EZ Hauler 3500/3800 Product Announcement

Subject: Outrigger Hub & Pin Update

Announcement: CCG1741

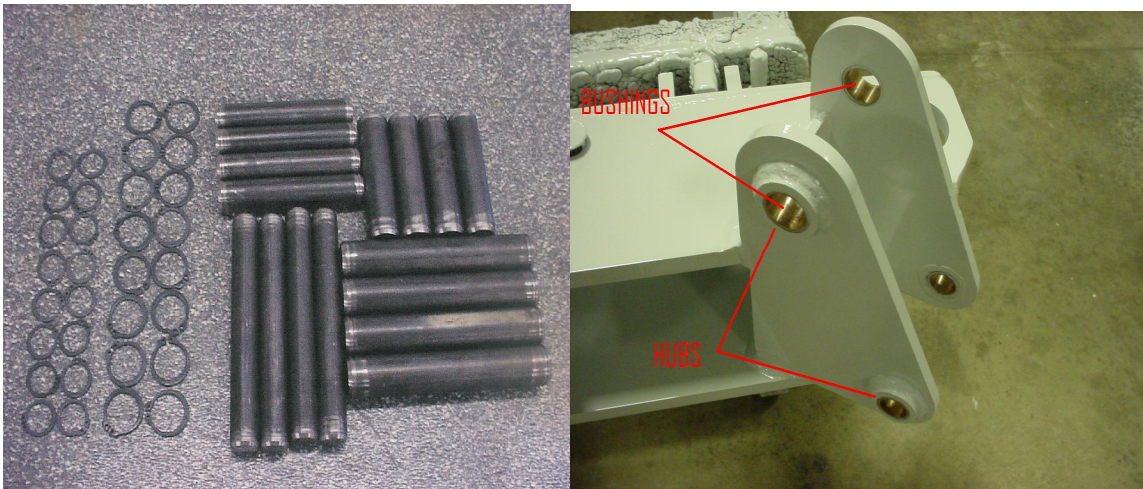
EZ Hauler models 3500/3800 manufactured prior to June 1, 2006 may experience hydraulic outrigger structural damage when overloaded. Failure to update could result in total outrigger failure!

This mandatory update does include that all pins are changed over from the “tear drop pin head w/bolt” style to the snap-ring retention pins. To install this update you will need the hydraulic outrigger pin & bushing kit, that is part number 011008-0331. You will also need the outrigger hub kit, that is part number 031108-0950. The hubs will need welded on, so have a qualified welder do this work.
